City of Mississauga Department Comments

Date Finalized: 2022-10-12 File(s): A456.22
Ward: 8

Property Address: 3559 Kelso Cres

Appendix 1 – Transportation and Works Comments

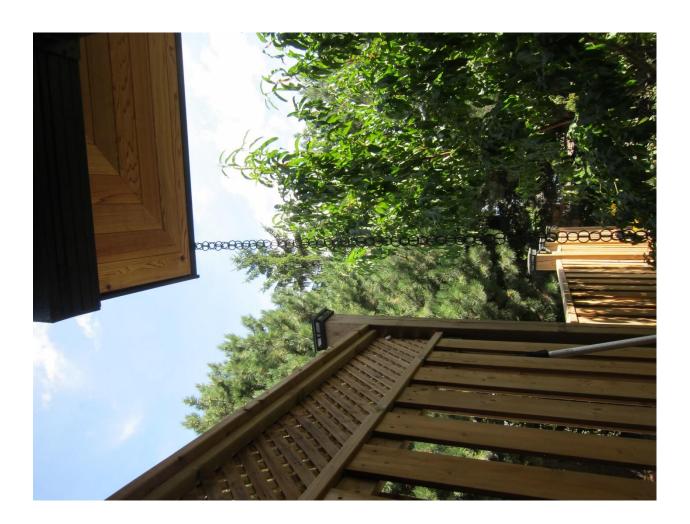
We are noting for Committee's information that any Transportation and Works Department concerns/requirements for the existing addition are being addressed by our Development Construction Section through the current Building Permit application BP-9ALT-21/9480. We ask that the existing eaves be equipped with a downspout directed in such manor to not impact the neighbouring lot.
